DONOHUE & STEARNS, PLC

Re: ZC Case 19-10/ Valor Development, LLC/ Square 1499

CRD's Response to Applicant's Contested Issues

June 21st, 2019 – 6:30AM

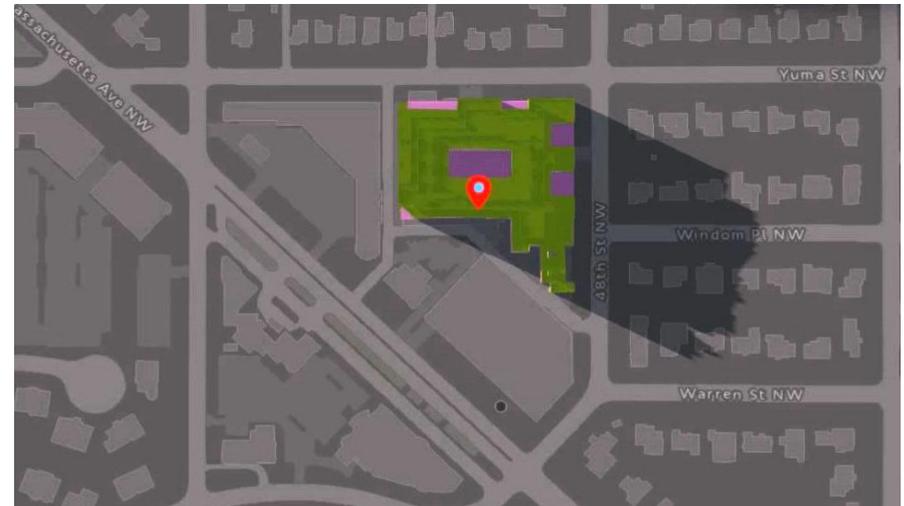
These 2 shadow studies, produced using the DCOZ 3D map program's solar study tool, shows the full extent of the solar impact of the proposed building on the surrounding neighborhood. Note the dramatic difference in impact between the two studies. This is not an inaccuracy of the program, but an omission of data, due to the times-of-day chosen.

June 21st, 2019 – 6:30AM – Existing Conditions

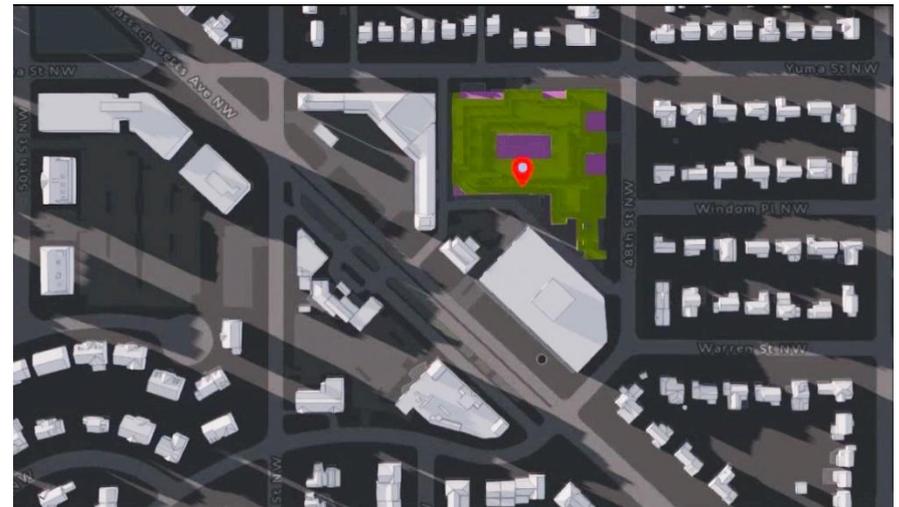
- At 6:30am the shadow of the ladybird will reach 600ft and cover the shopping centers on both sides of Massachusetts Ave.
- At 8pm the shadow will impact more than a dozen homes East and SE of the development. Note these homes currently enjoy full sun at this time.

Dec 21st, 2019 – 8:00AM

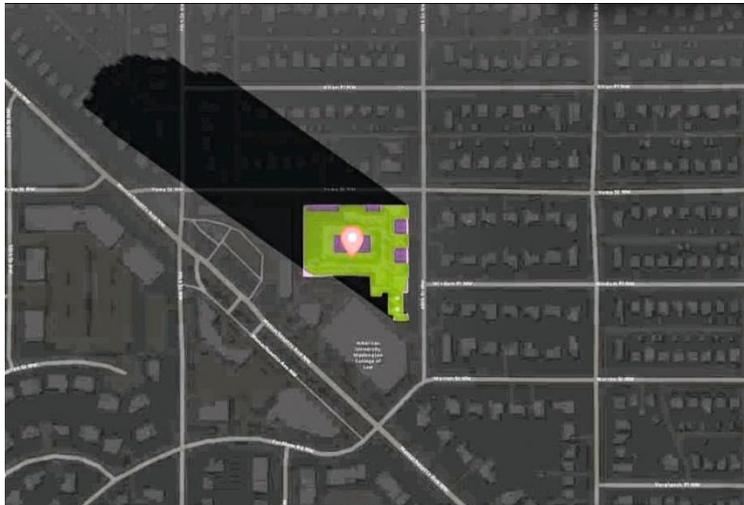
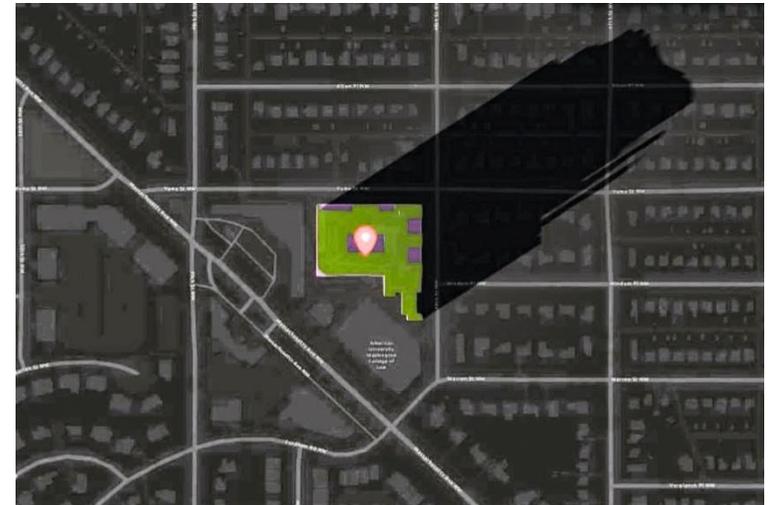
- These 2 shadow studies, produced using the DCOZ 3D map program's solar study tool, shows the full extent of the solar impact of the proposed building on the surrounding neighborhood. Note the dramatic difference in impact between the two studies. This is not an inaccuracy of the program, but an omission of data, due to the times-of-day chosen.
- At 8am the shadow of the ladybird will reach 700ft and cover over 2 dozen homes to the NW.
- At 4:30pm the shadow will impact nearly 3 dozen homes across 6 city blocks to the NE.
